Access Compliance Report

Public Rights-of-Way

(Pedestrian Signals)

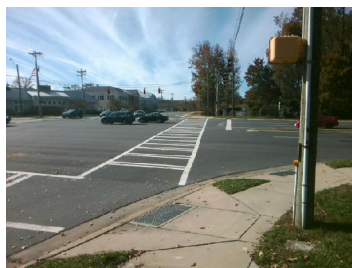
PROW/ADA: TMUTCD 4e.08, R404.2, R406.2, R404.7.3

Possible Solutions: Replace Signal Push Button With APS Button on New Post. Remove & Relocate Sign.
